**TOWN OF BLIND RIVER
REQUEST FOR TENDER
NEW BLIND RIVER WATER TREATMENT PLANT INTAKE AND LOW LIFT PUMPING STATION
CONTRACT NO. PS-2026-01**

**ADDENDUM #5
February 20th, 2026**

2 SPLIT DUCTLESS AIR CONDITIONING UNIT PIPING SCHEMATIC
 AD-6-M501 SCALE: NTS

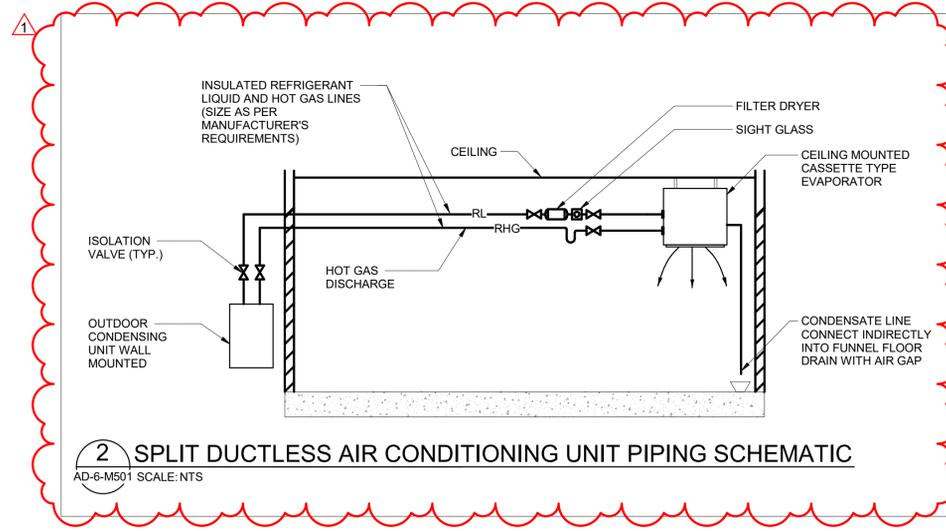
Q10: Clarify location of AC refrigeration system piping.

A10: Per Change 2.1 above, detail AD-6-M501 has been revised to indicate that the drain shall be indirectly connected to the building sanitary system. The evaporator and refrigerant piping shall be suspended from the ceiling. Installation shall conform to the revised detail.
